UC Merced HBS-ME Meeting Minutes

Date: February 11, 2021
Project: UCM HBS Bldg DPP
Project Number: 2019053
Copy to: File

From: Matt Pietras
Purpose: Psychology Sub-Ctte Programming Workshop
Location: Web Conference

PSYCHOLOGY ADJACENCY DIAGRAM

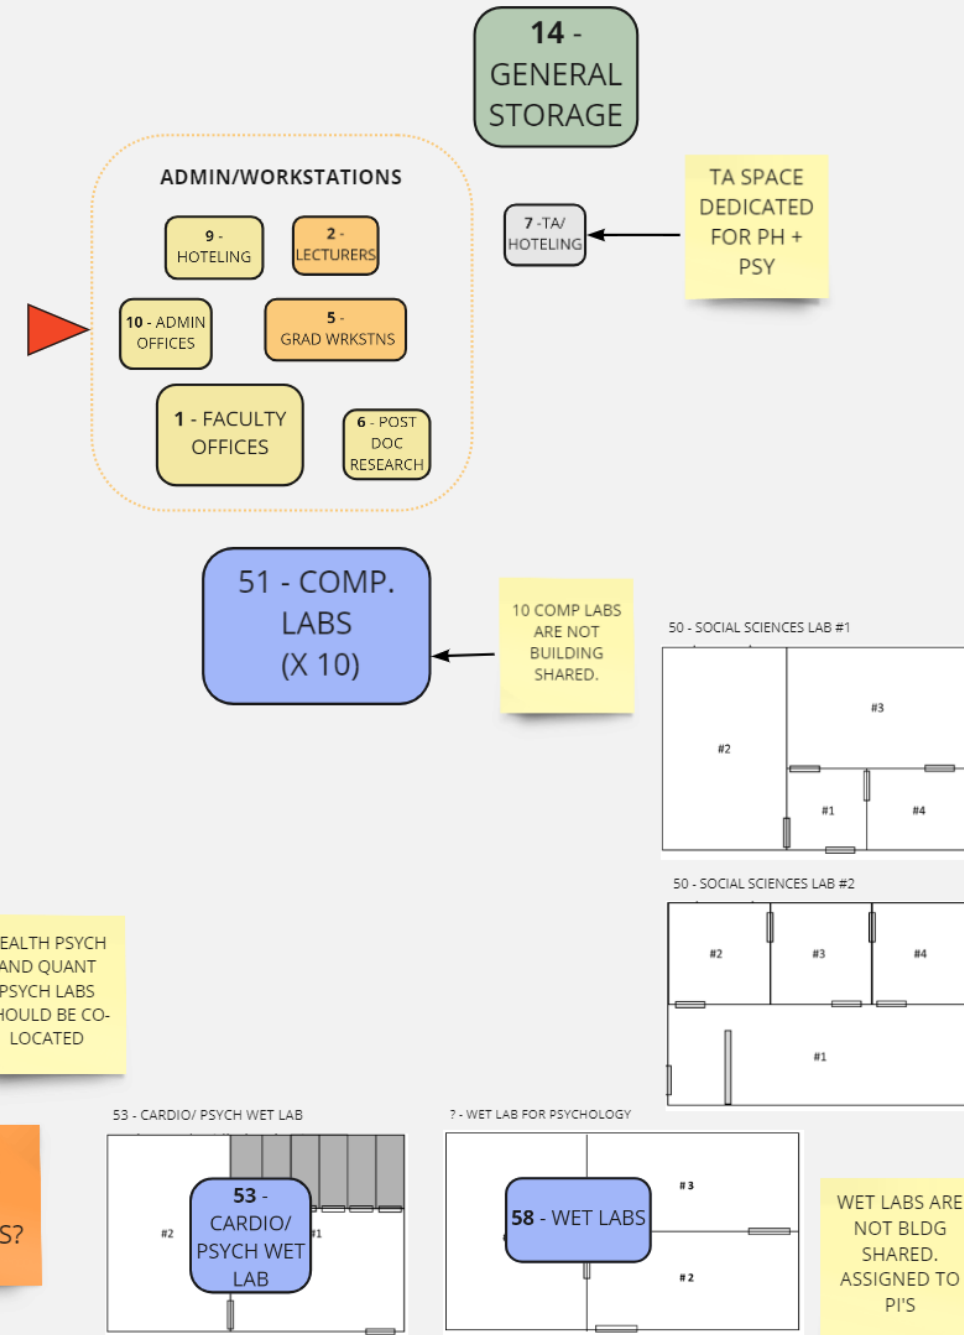
WAYFINDING / ORIENTATION IS CRITICAL

MEETING LOCATION FOR PARTICIPANTS GOOD BUT DOES THIS SPACE NEED TO BE MANNED BY A RECEPTIONIST?

DEVELOPMENTAL LABS HAVE SPECIFIC NEEDS TO BE ON THE GROUND FLOOR

BREAK OUT SESSIONS?
